Access Compliance Report Public Rights-of-Way (Pedestrian Signals)

Main Street: RED_HILL_AVE Cross Street: IRVINE_BLVD Location: NW

ADA ID: SGAT211027091423 Signal Type: One Push Button-APS Overall Compliance: No Severity Scores: BTN 1: 25 BTN 2: N/A No BTN: N/A

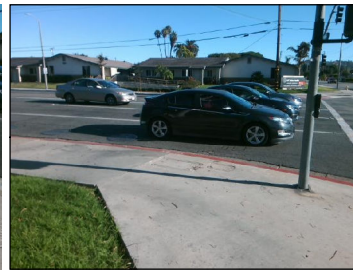
Possible Solutions: Remove and Replace Clear Space.

OC Std/PROW: R404.2
